Model: Model Sh-MF1 PFU option		Date: 24-Feb-12	No.: RM375001
Subject: Part catalog correction		Prepared by: T.Hirai	
From: 3rd Tech Service Sect., MFP/P Tech Service Dept.			
Classification:	<input type="checkbox"/> Troubleshooting <input type="checkbox"/> Mechanical <input type="checkbox"/> Paper path <input type="checkbox"/> Product Safety	<input checked="" type="checkbox"/> Part information <input type="checkbox"/> Electrical <input type="checkbox"/> Transmit/receive <input type="checkbox"/> Other ()	<input type="checkbox"/> Action required <input type="checkbox"/> Service manual revision <input type="checkbox"/> Retrofit information <input type="checkbox"/> Tier 2

Model: Model Sh-MF1 (PFU)		Date: 28-Mar-12	No.: RM375002
Subject: Check points at installation (Tray side fences or Paper end sensor were detached)			Prepared by: T.Hirai
From: 3rd Tech Service Sect., MFP/P Tech Service Dept.			
Classification:	<input type="checkbox"/> Troubleshooting <input type="checkbox"/> Mechanical <input type="checkbox"/> Paper path <input type="checkbox"/> Product Safety	<input type="checkbox"/> Part information <input type="checkbox"/> Electrical <input type="checkbox"/> Transmit/receive <in

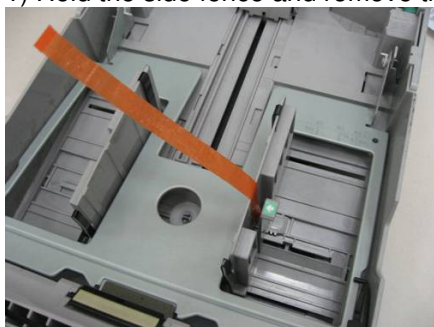
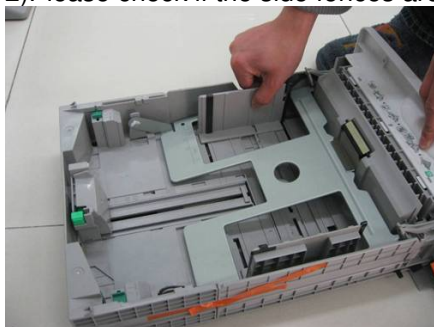
1. Side fences are detached
2. Paper end sensor is detached.

1. During transportation.
Remove the side fences together when removing orange tapes at installation.
2. Orange tape pushed and detached the paper end sensor.

1. Please check whether the side fences are detached at installation. Even if fences were not detached, be careful when you remove the orange tape. Please refer to the following procedure.

- 1) Hold the side fence and remove the orange tapes one by one.

- 2) Please check if the side fences are moving smoothly.

- Deleted the orange tape on the side fences.
- Set the side fences wider than A4 size.

Correct position (can see)

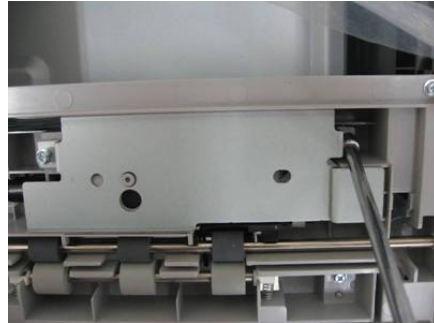
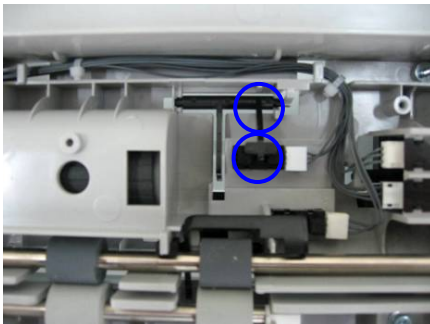
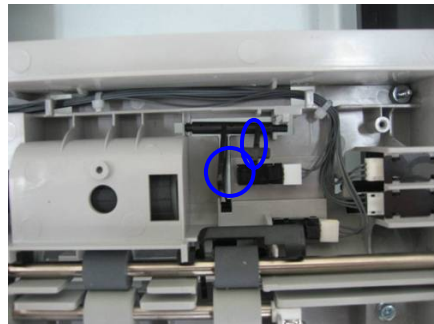
2. Please check whether paper end sensor is detached or not. If the paper end sensor is detached, please reattach the paper end sensor as follows.

Check whether you can see the paper end sensor or not.

If the paper end sensor is in an incorrect position (cannot see), please reattach as follows.

1. Remove the upper cover of the PFU. 2. Remove 1 screw.

3. Set the paper end sensor in the correct position.

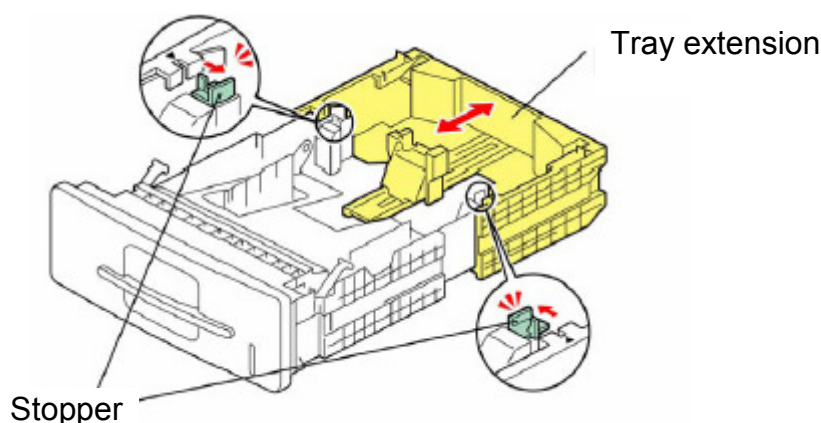
A paper feed jam or non-feed occurs when feeding the paper from a mainframe paper tray.

The stopper breaks and the tray extension extends out too far, causing the end fence to retract.

The shape of the stopper was changed, and four screw holes were added so that the extension tray can be fixed in place for LT/A4 and LG paper sizes.

- If the user always uses the same paper size, fasten the extension tray in place with screws.
- ***For all other users, fix the extension in place for LG sized paper.***

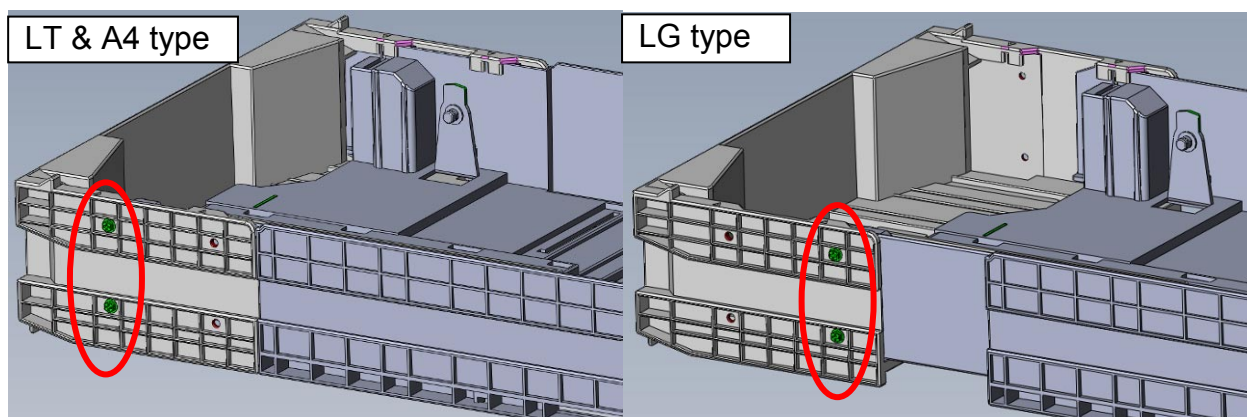
Important: *If there is no available screw hole in the user's tray, replace the tray with the following new part (which contains the required screw holes).*

- The new screw holes are for LT/A4 and LG paper sizes. If the user always uses the same paper size, fix the extension tray in place at the corresponding position. ***If the user does not always use the same paper size, fix the extension in place for LG sized paper.***
- Insert the screws from the outside face of the tray. For each paper size, there are two screw holes, as shown.
- Be careful not to over-tighten the screws.

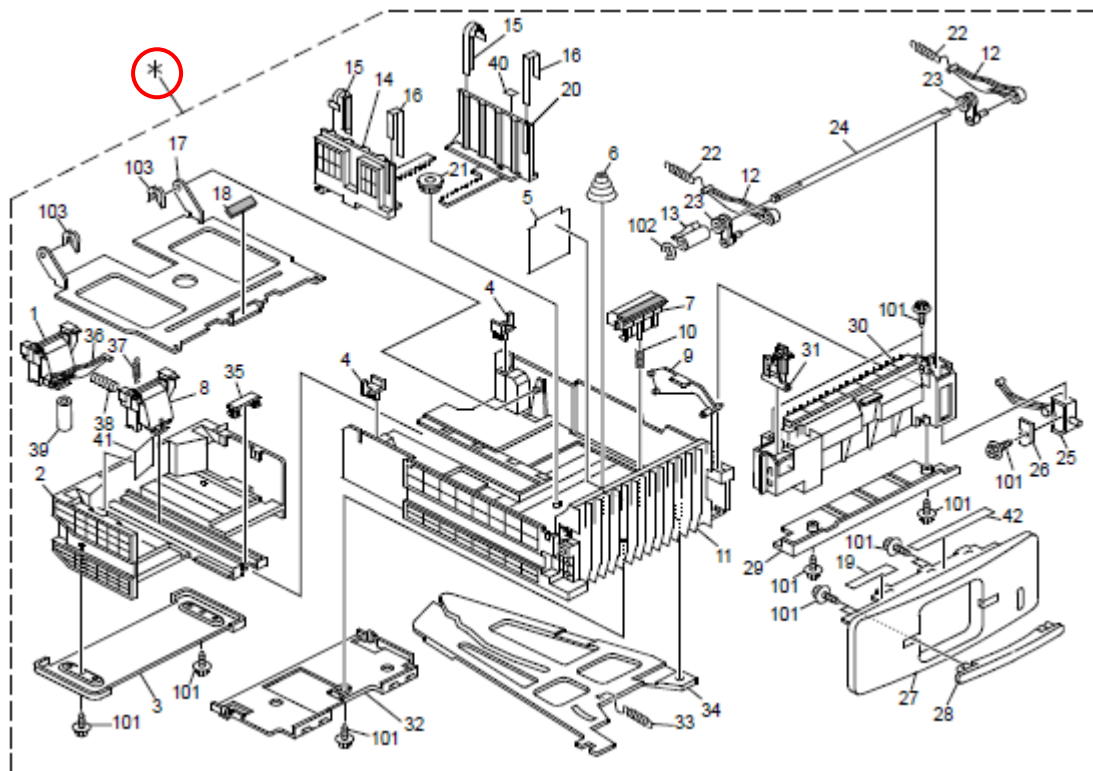
Change/ Reason: This part number was missing from the parts catalog.

Part Number	Description	Q'ty	Int	Page	Index	Note
M3752550	PAPER TRAY:ASS'Y	1	-	5	*

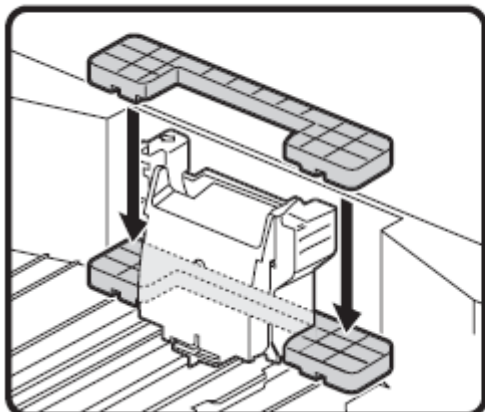
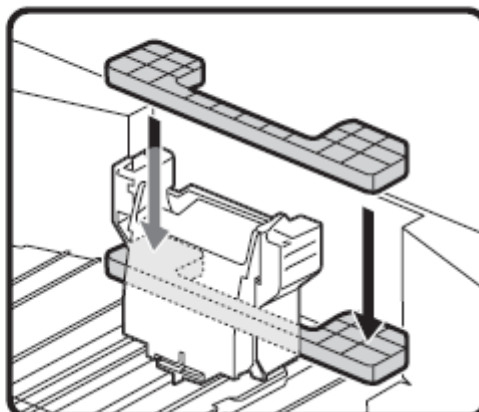
A paper feed jam or non-feed occurs when feeding the paper from optional paper trays.

End fence is not set correctly.

- A.** A spacer was added behind the end fence.
- B.** An instructional leaflet for users was inserted in the paper tray.
- C.** The end fence is fixed in the LT position before shipment from the factory. (The side fences are fixed in the A4 position.)
- D. A spacer with reinforced double-sided tape was added (P/N: M0212570).***

Attach the following parts (***P/N: M0212570***) behind the end fence, as shown, using double-sided tape.

2.Paper Feed Unit 2 (M375/M376)

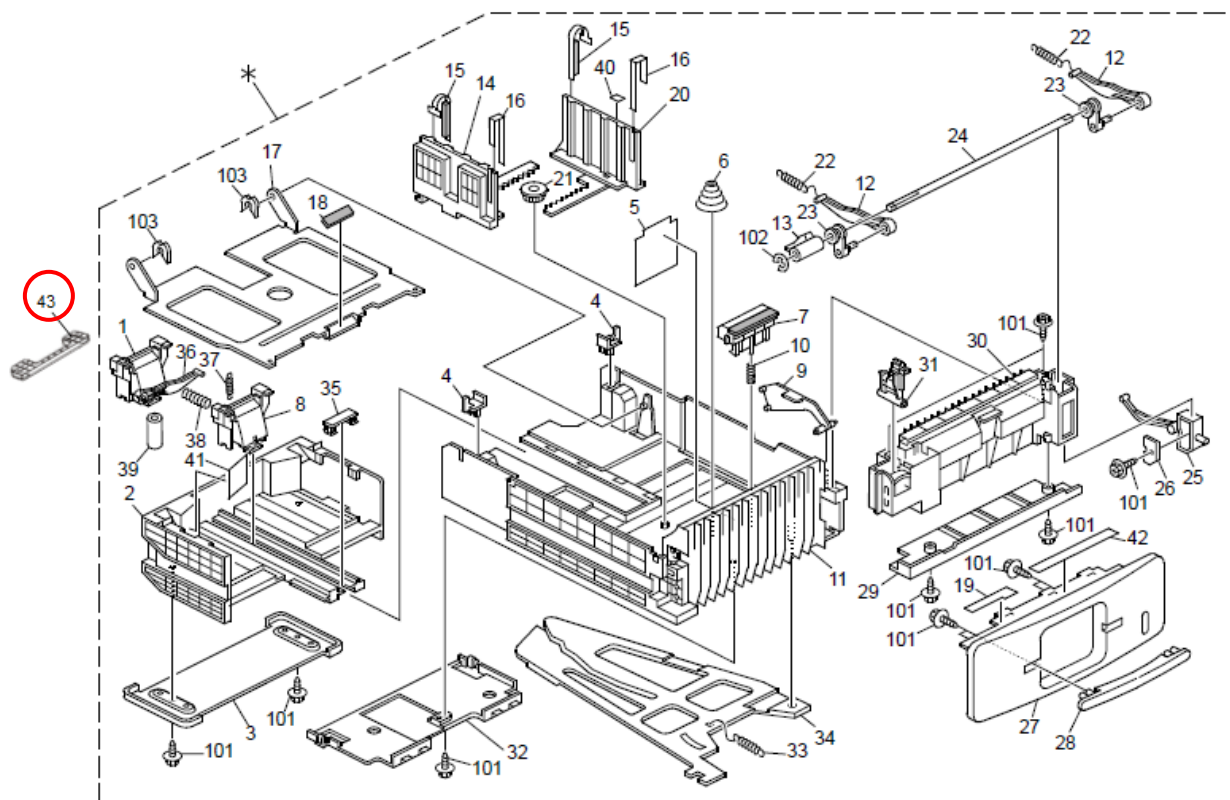
Change: A spacer was added.

Reason: To make sure that the operator sets the end fence in the correct position.

Old part number	New part number	Description	Q'ty	Int	Page	Index	Note
	M0212564	END FENCE:SPACER	0-1	-	5	43

2.Paper Feed Unit 2 (M386/M389)

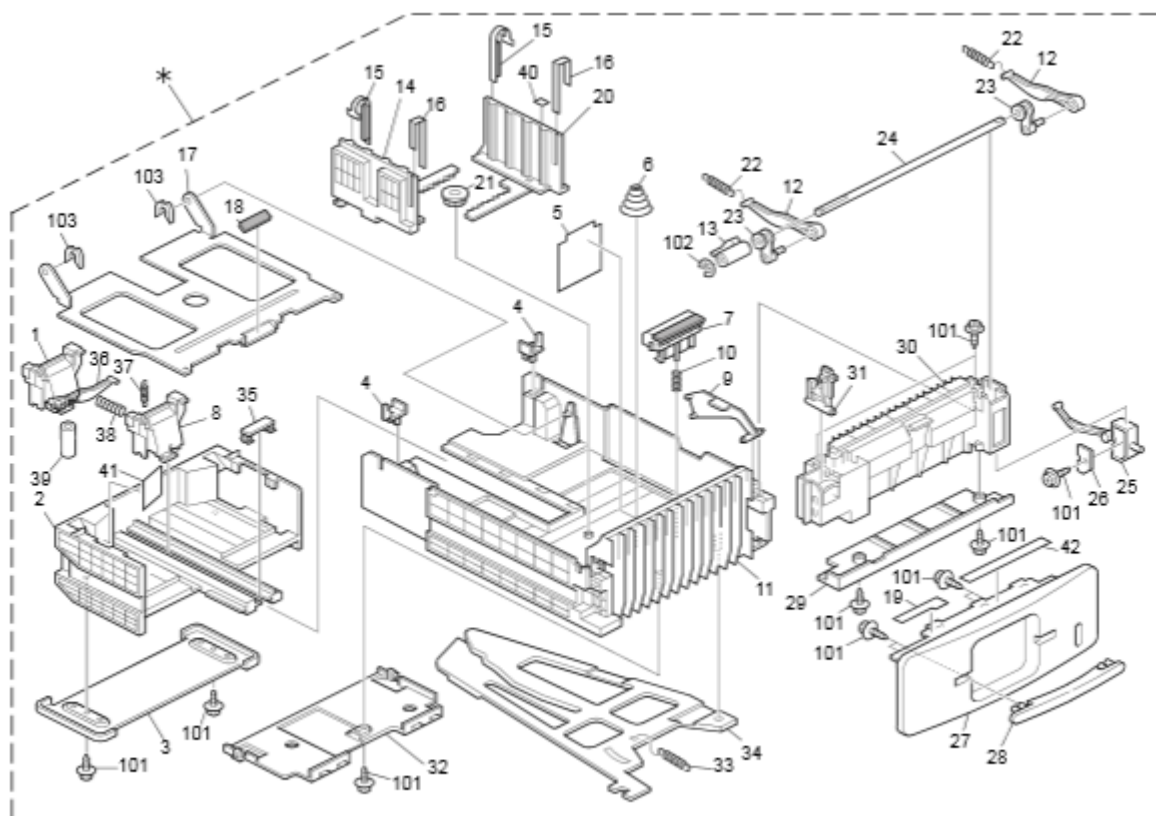
Change/Reason: The following part number and index number were changed.

Old part number	New part number	Description	Q'ty	Int	Page	Index
M0212659	M0522670	TRAY BOTTOM PLATE	1	-	5	17

3.Paper Feed Unit 3 (M375/M376)

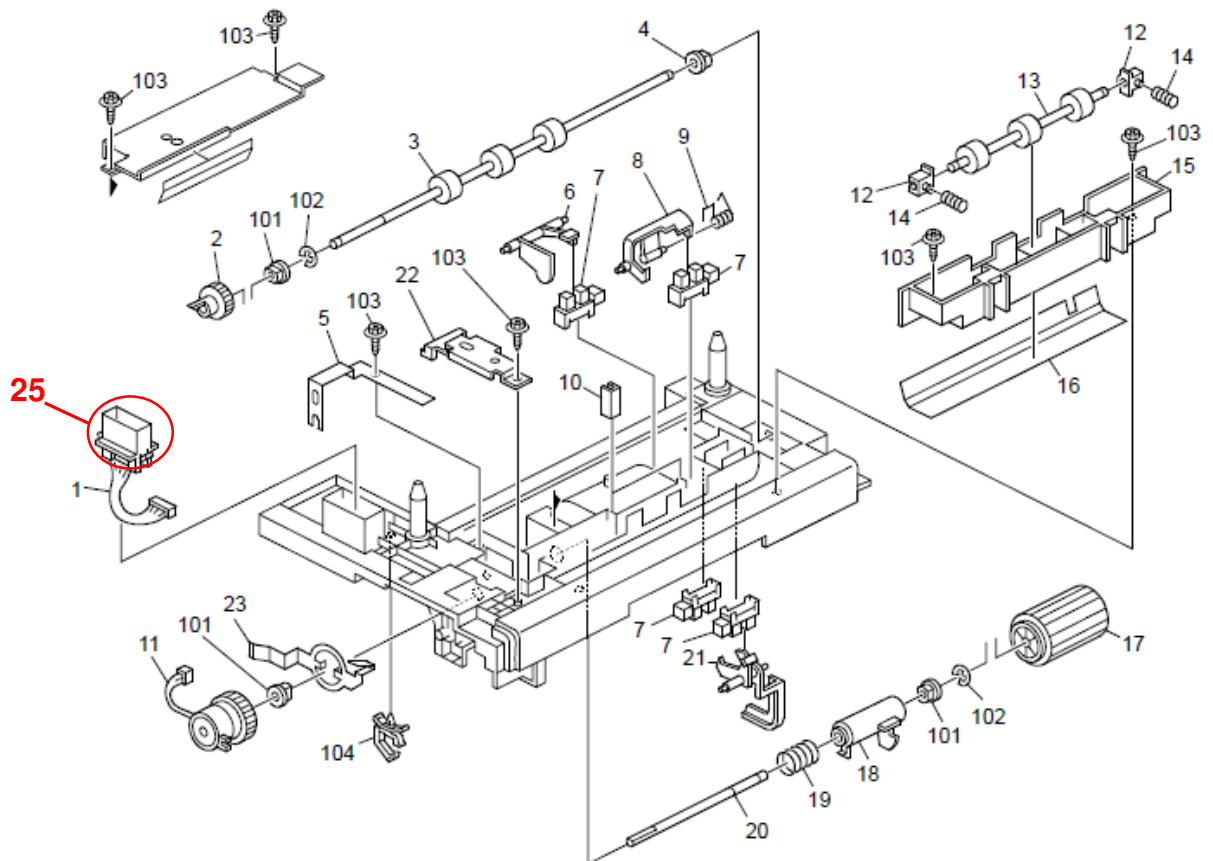
Change/Reason: This part number was missing from the parts catalog.

Part number	Description	Q'ty	Int	Page	Index	Note
11029811	CONNECTOR:1-1612256-4	1	-	7	25

4.Paper Feed Unit 4 (M375/M376)

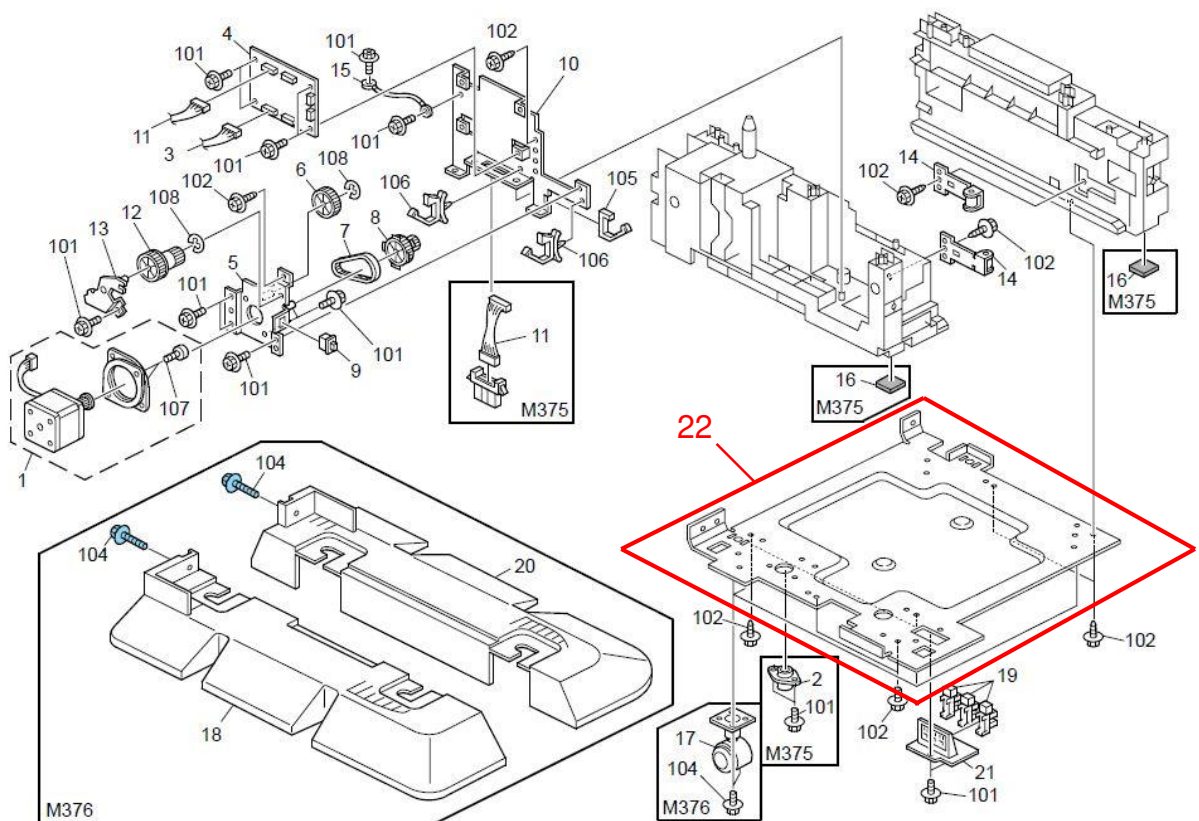
Change: The following part was newly added as a service part.

Reason: To meet requests received from the field.

Old part number	New part number	Description	Q'ty	Int	Page	Index	Note
-	M3751051	FRAME:LOWER:HELENA-MF	1	-	9	22	M375 only
